ADDENDUM NUMBER TWO (2)
DATE: 05/14/2026

Project: ValloonPark Improvements 2026 Owner: City of Valdosta, Georgia

Modifications to Bidding Documents:

Valloton Questions and Responses

DUGOUTS FOUNDATION,
SLAB, ROOF FRAMING PLAN,
AND SECTIONS & DETAILS

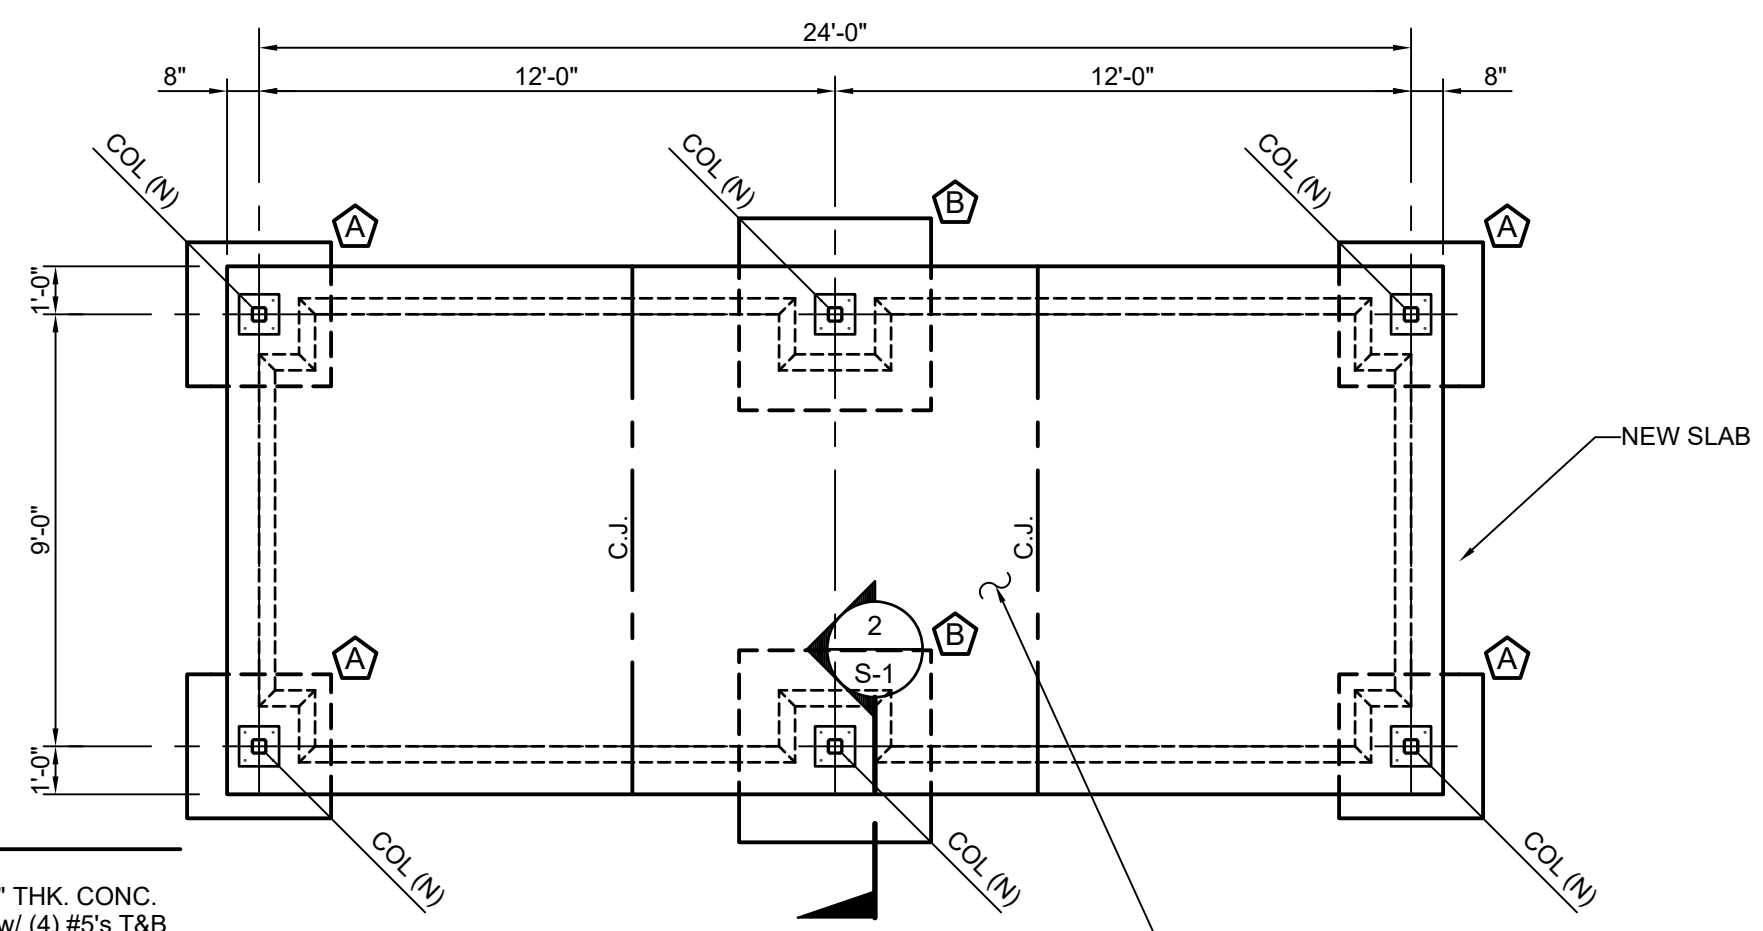
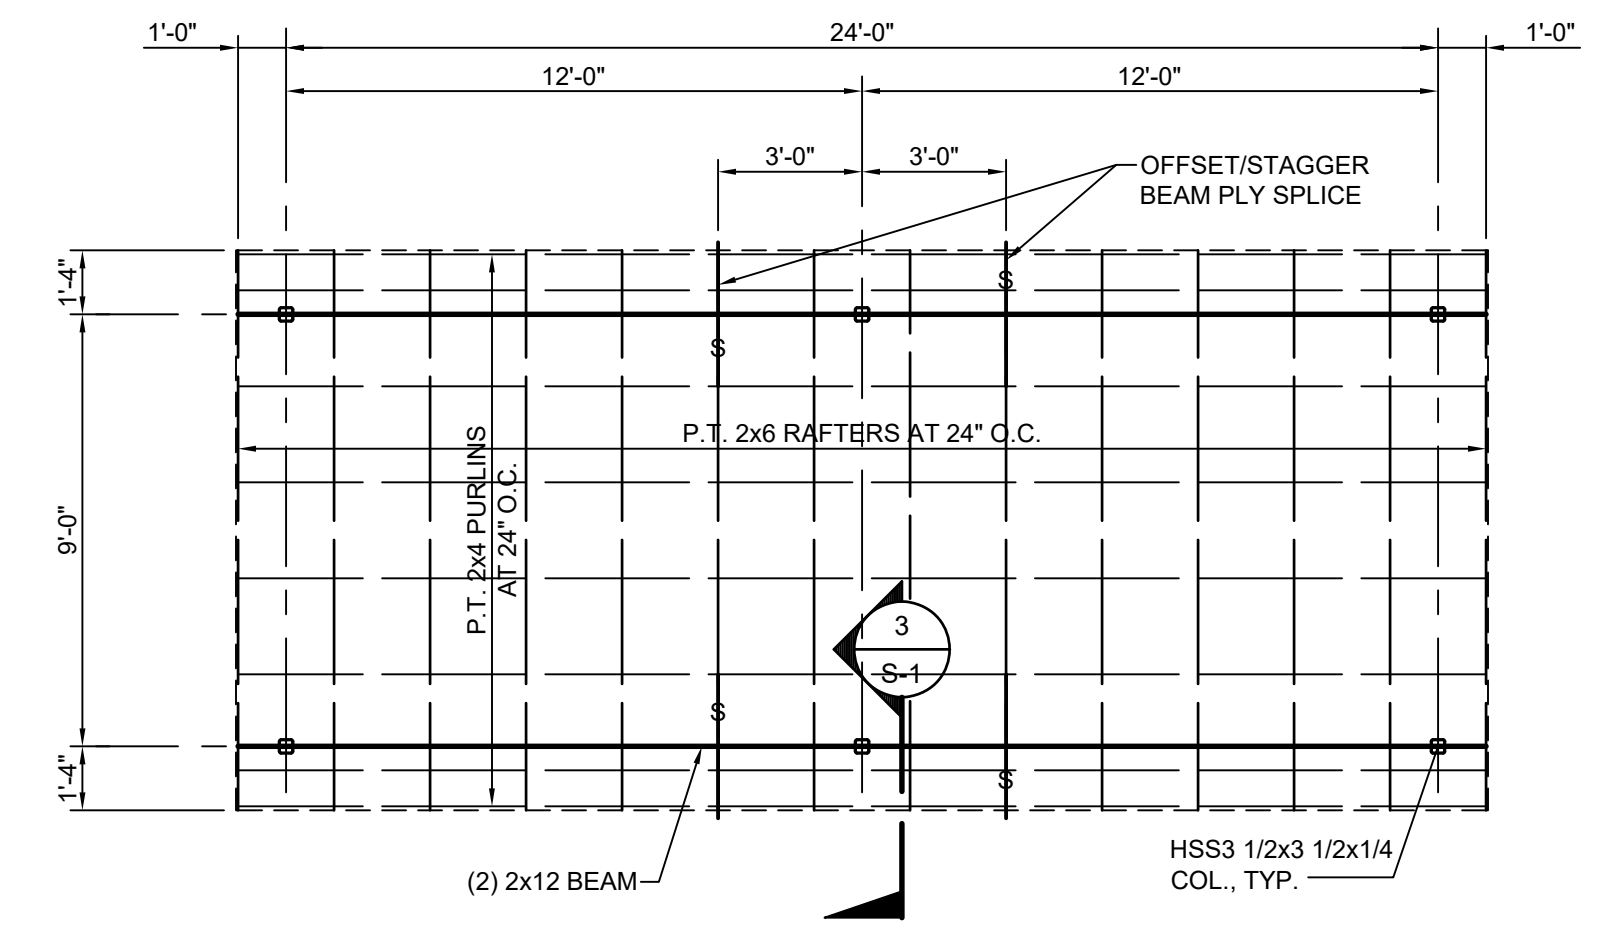
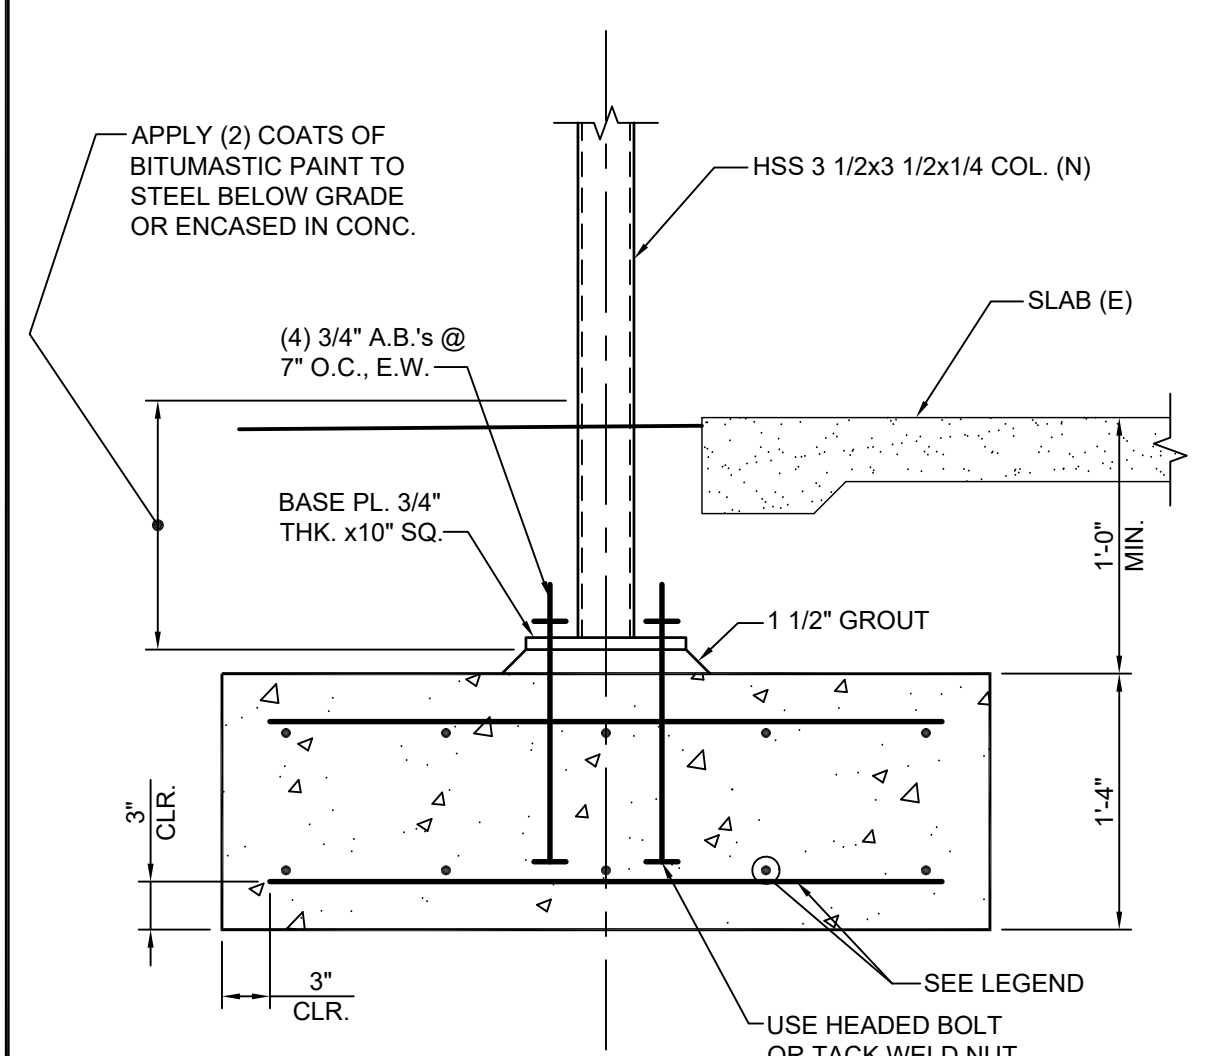
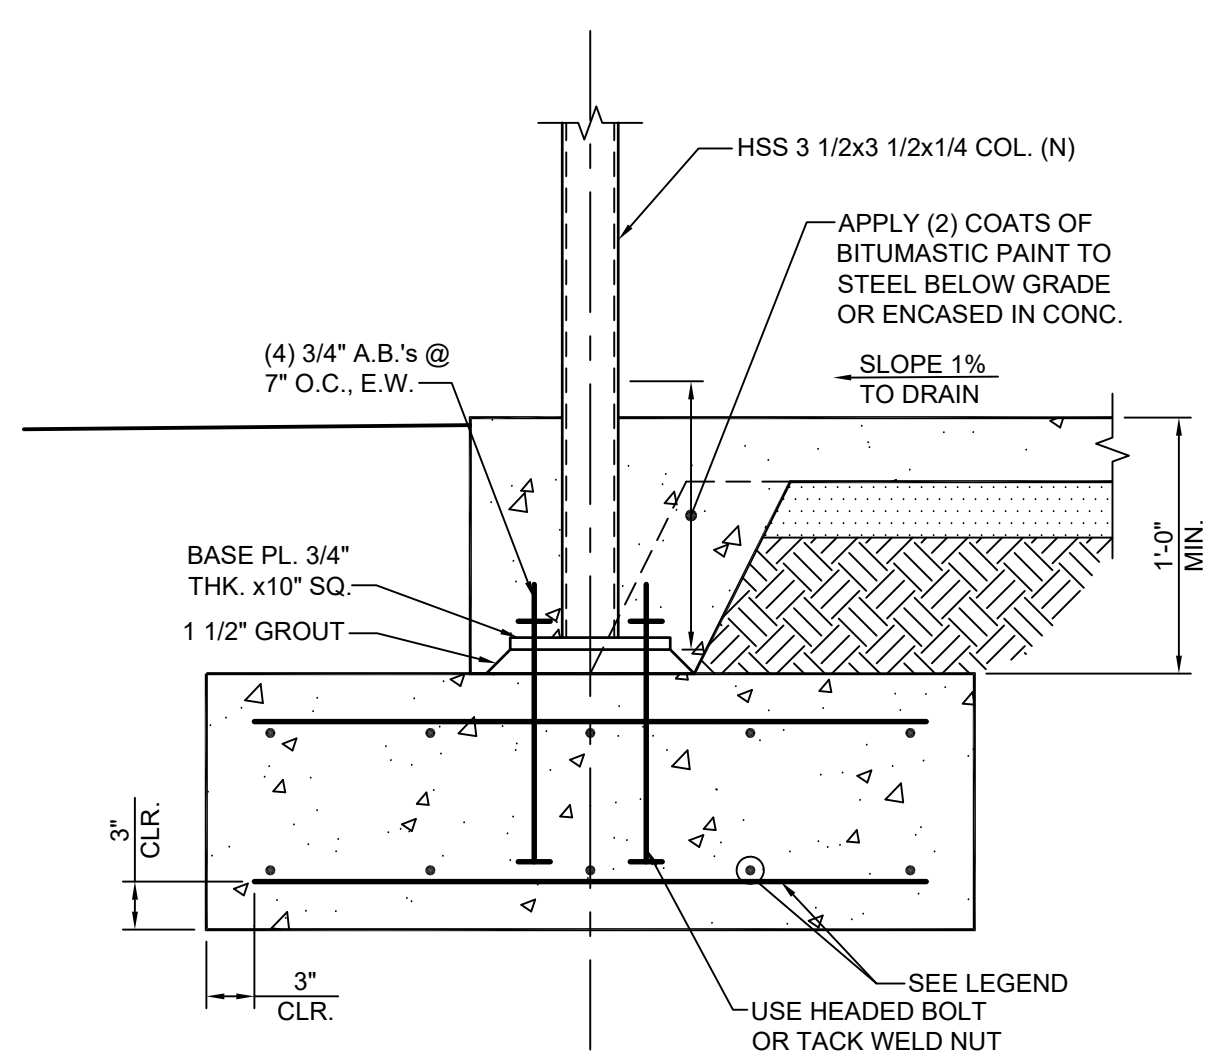
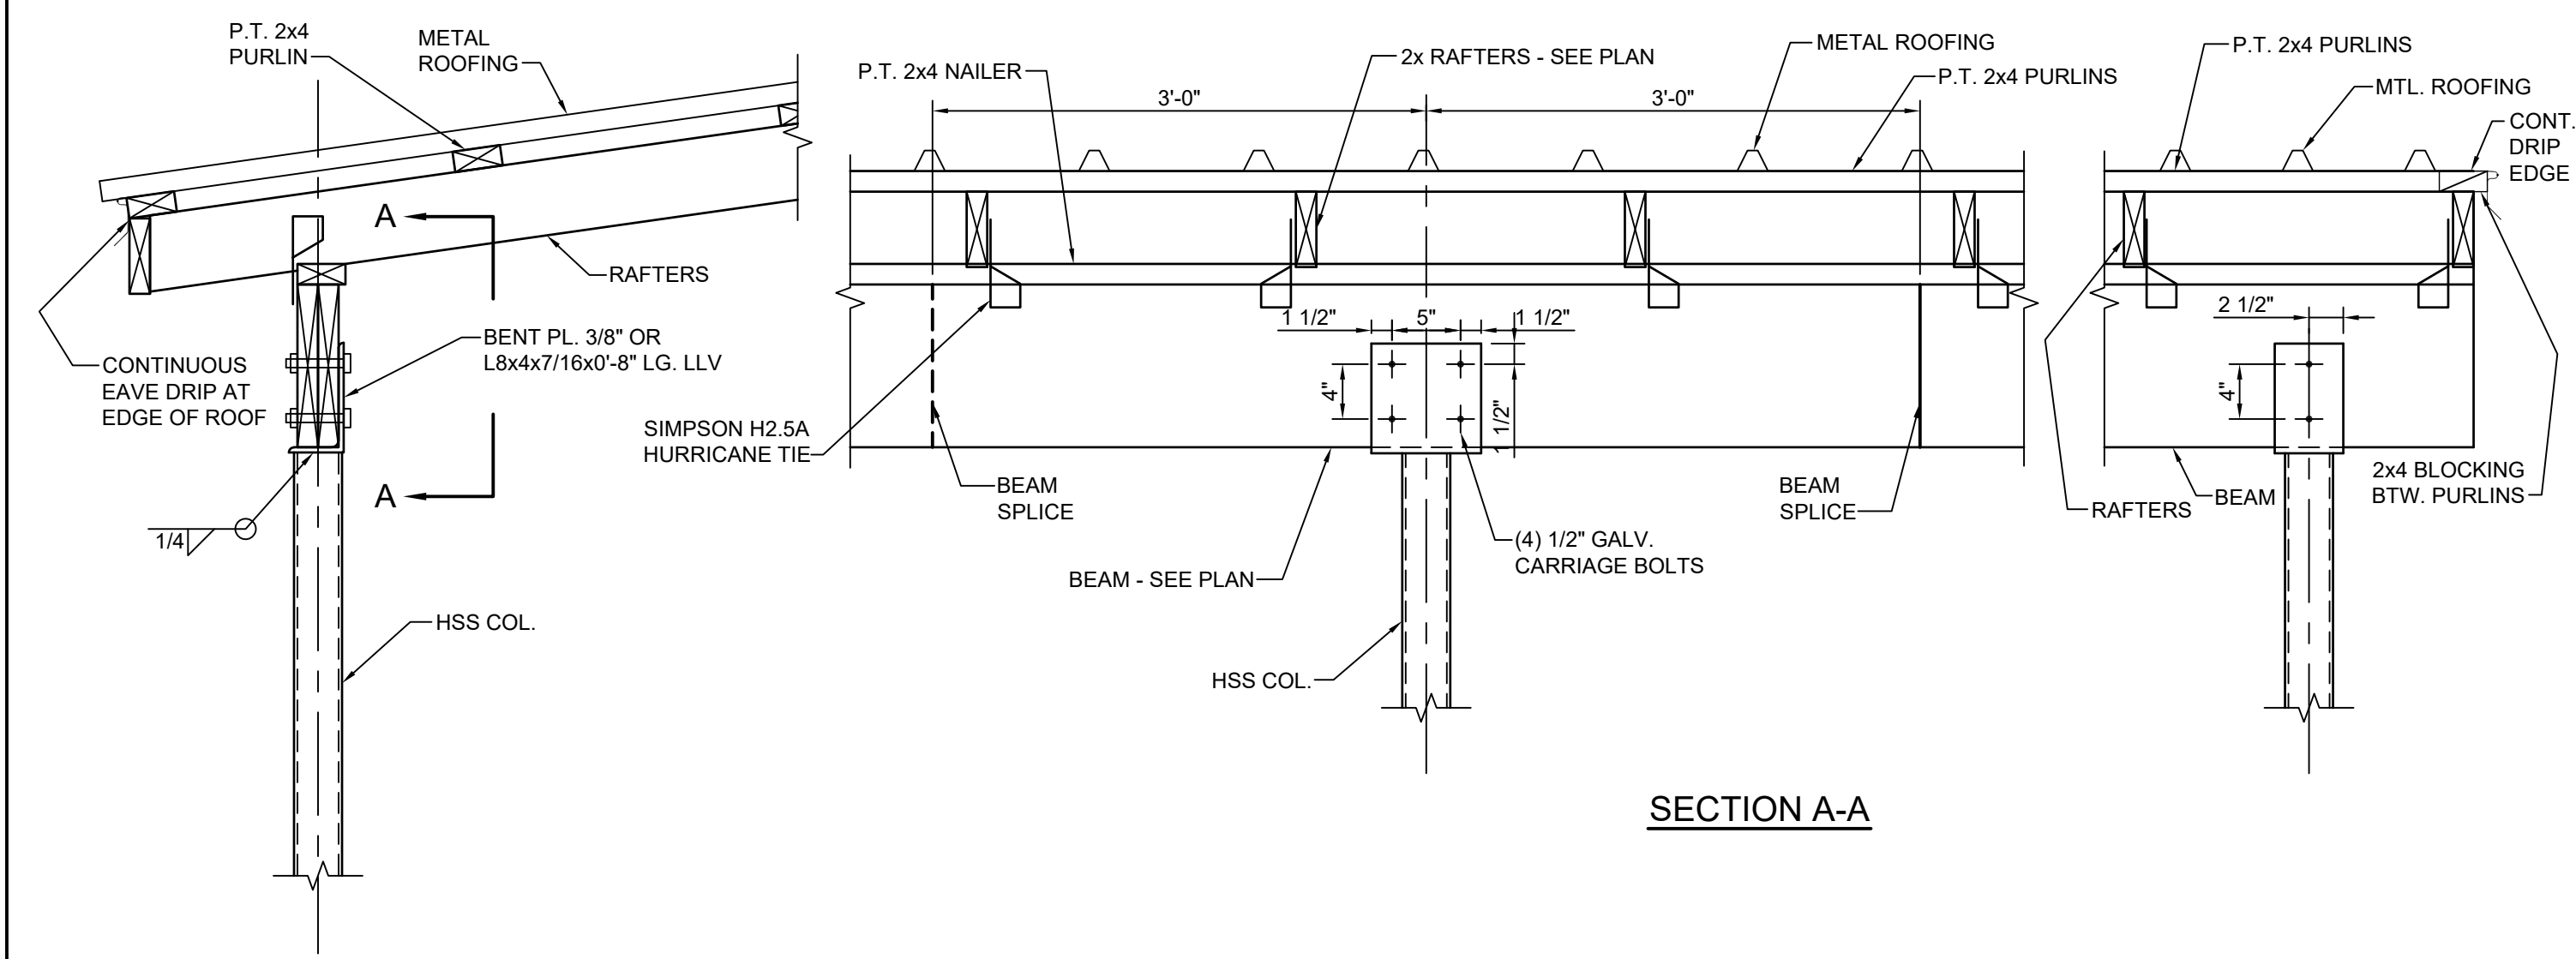
8. Will there be a sidewalk leading to Skate Park? YES. LINE ITEM 19 (concrete slab on grade per c.y.) WILL COVER INSTALLATION
9. Bid Line Item # 9- Is construction of new dugouts to match existing framing and roof? NO; STRUCTURAL PLANS S-0 AND S-1 ARE ISSUED IN ADDENDUM #2 WITH DUGOUT CONSTRUCTION DETAILS.

18. Sheet C-1 Drawing Index shows two structural sheets S-0 and S-1. These were not included in the bidding documents. Please provide. SEE #9 ABOVE.
19. Please provide construction details and specifications for the dugout construction. SEE #9 ABOVE.

20. Existing dugouts have wooden posts that are set in the concrete slabs. Is cutting the posts off flush with the concrete slab acceptable? YES, & SEE #9 ABOVE.

- UCS/Bid Form revision - The playground component has been removed from the contract, and the selected sole source vendor for the skate park is Spohn Ranch. The Unit Cost Schedule/Bid Form is modified accordingly. A revised Proposal Form is included.
- Structural plan sheets detailing the dugout construction are issued and are attached.
